Site Survey of Selected Items  
for  
Compliance with the Americans with Disabilities Act  
(ADAAG)  
and  
Title 24 of the CBC

This report identifies noncompliant items in remodeling and renovation at an existing school site and provides recommended methods for removal of the barriers identified.

The site survey of Walgrove Elementary School was conducted on February 28, 2007 during a spot check for compliance with the Americans with Disabilities Act Guidelines (ADAAG) and Title 24 of the CBC

# Facility Name: Walgrove Elementary School

Accessible Parking

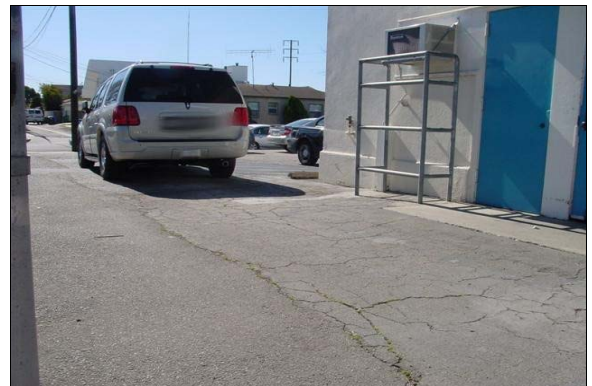
**Finding:** The parking signage at the standard accessible space contains the word "Handicapped."

**Full Rec** Install a permanently posted reflectorized sign measuring 70 square inches that includes an ISA symbol adjacent to and visible from the accessible parking space (see CBC 1129B.5). The bottom edge of the sign must be mounted 80 inches from the ground surface so that it cannot be obscured by a parked vehicle (see CBC 1129B.5). Signage shall not contain the word "Handicapped."

Accessible Parking

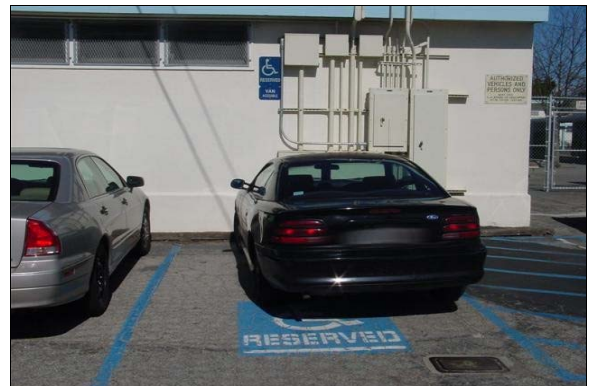
**Finding:** There is warning signage posted at the entrance from Appleton Way regarding unauthorized use of accessible parking spaces in the parking lot, but the sign contains the word "Handicapped."

**Full Rec** Post a sign in a conspicuous place to the entrance of the parking lot, or immediately adjacent to and visible from each accessible parking space. The warning sign shall measure at least 17" by 22" and consist of lettering at least 1" in height that clearly and conspicuously states the following; "Unauthorized vehicles parked in designated accessible spaces not displaying distinguishing placards or license plates issued for persons with disabilities may be towed away at owner's expense. Towed vehicles may be reclaimed at \_\_\_ or by telephoning \_\_\_." Fill in the blank spaces with appropriate information as a permanent part of the sign and maintain the currency of the information. Be sure to add the CVC 22511.8(a)(d) to the sign.

Boys Restroom Building A

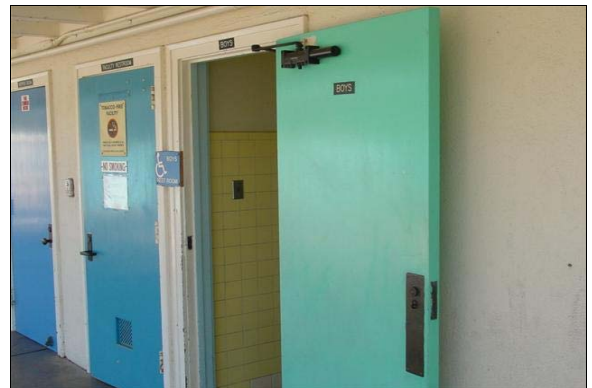
**Finding:** The bottom 10 inches of the door does not provide a smooth, uninterrupted surface, or panel to allow the door to be opened by a wheelchair footrest without creating a trap or hazardous condition, due to a doorstop.

**Full Rec** Remove the doorstop from the door to provide a smooth, uninterrupted surface for the bottom 10 inches of the door.

Boys Restroom Building A

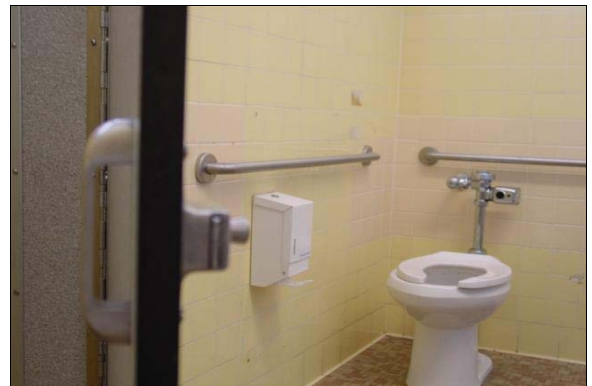
**Finding:** There is less than 24 inches of clearance on the latch side of the exterior entrance door to the restroom, from the push side.

**Full Rec** Provide at least 24 inches of latch side clearance at the entrance door to the restroom (see ADAAG 4.13.6 and Figure 25). Otherwise, install an automatic door opening device to the primary entrance complying with ADAAG 4.13.12 and ANSI/BHMA A156.10, 1985, standards.

Girls Restroom Building A

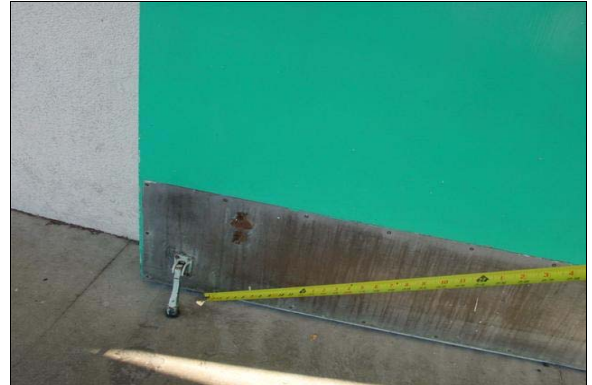
**Finding:** There is no signage indicating accessibility on the latch side of the entry door of the restroom. There is Title 24 gender use signage on the entrance door.

**Full Rec** Post signage centered 60 inches above the ground surface on the latch side of the entrance door identifying the restroom as accessible. Signage shall include Braille and raised lettering, the gender or unisex use symbol and the ISA symbol.

Girls Restroom Building A

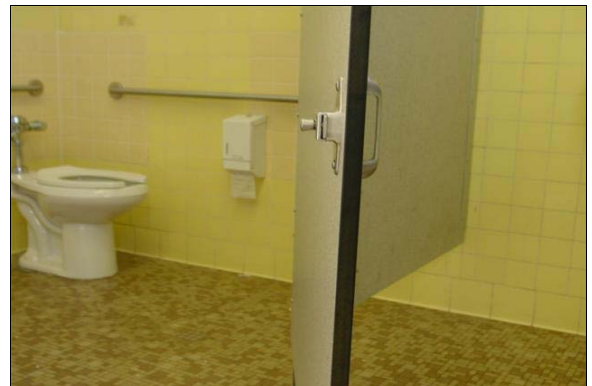
**Finding:** There is 2 inches of clearance on the latch side of the exterior entrance door to the restroom, from the push side.

**Full Rec** Provide at least 24 inches of latch side clearance at the entrance door to the restroom (see ADAAG 4.13.6 and Figure 25). Otherwise, install an automatic door opening device to the primary entrance complying with ADAAG 4.13.12 and ANSI/BHMA A156.10, 1985, standards.

Girls Restroom Building A

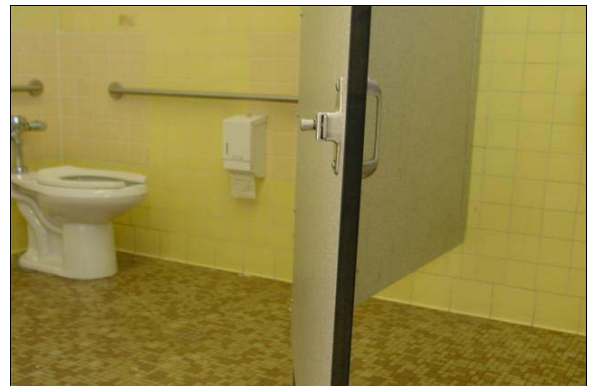
**Finding:** The height of the side grab bar in the stall designated to be accessible in the restroom is 33 inches for restrooms used primarily by children. The distance from the end of the side grab bar to the back wall is 13 3/4 inches.

**Full Rec** Remount the side grab bar in the stall designated to be accessible in the restroom at a height 27 inches above the finished floor to accommodate children ages 5 thru 12 (see ADAAG A4.16.7). The grab bar shall be no more than 12 inches from the back wall. Grab bars must be able to support a point load of at least 250 pounds and shall be less than the allowable shear stress of the grab bar material.
